PCN	Product Change Notification	De-22-09-0629	
Product	MaxiBridge	Date of Publication:	
		06.09.2022

Title: MaxiBridge Male Housing injection gate modification

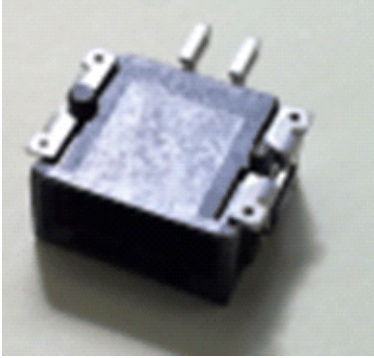
Valued customer,
 one of our molding tools for the MaxiBridge male housings has been modified on the gate side with a 0.1mm recess in order to avoid issues with sprue protrusion.
